From: [Wedin, Lathan](#)
To: [Kelee Hodges](#); [Josh Fredrickson](#)
Cc: [steve.lathrop1](#); [steve.lathrop1](#); [Kelly Bacon \(CD\)](#)
Subject: RE: LP-22-00004 Suncadia Ph 1 Div 14 - Preliminary Plat PW Survey Review
Date: Friday, November 18, 2022 12:37:58 PM
Attachments: [image001.png](#)
[LP-22-00004 Suncadia Ph 1 Div 14 KCPW Plan Review Team Comments 11172022 Revised.pdf](#)

From: Kelly Bacon (CD) <kelly.bacon.cd@co.kittitas.wa.us>
Sent: Monday, November 14, 2022 5:21 PM
To: Wedin, Lathan <lwedin@suncadia.com>; steve.lathrop1 steve.lathrop1 <Steve@lwhsd.com>
Cc: Kelee Hodges <kelee.hodges.pw@co.kittitas.wa.us>
Subject: LP-22-00004 Suncadia Ph 1 Div 14 - Preliminary Plat PW Survey Review

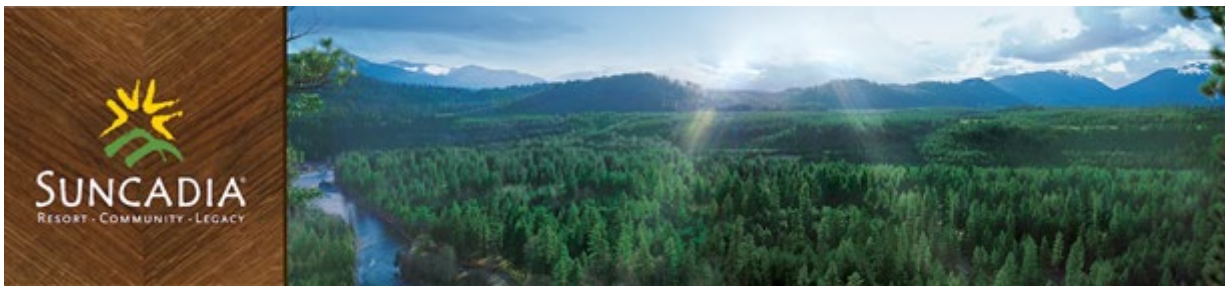
Comment #6 appears to be a conditional preliminary plat comment to be resolved prior to final as the road labelling as commented/requested is found only in the final plat part of KCC.

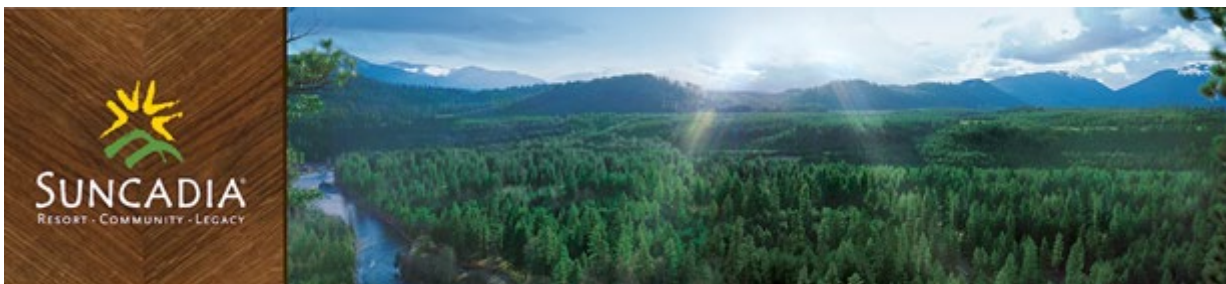
I also clarified Public Works Survey comment #4 (copied below) with our civil engineer and essentially that comment does not apply to preliminary plat / Suncadia. The easements have been contemplated, but at preliminary plat everything has not been fully designed therefore no easements exist at this point.

“4. Sewer, stormwater, and road cut/fill slope easements should be contemplated. All easements shown upon referenced conceptual and preliminary documents shall be included on the face of the Plat.”
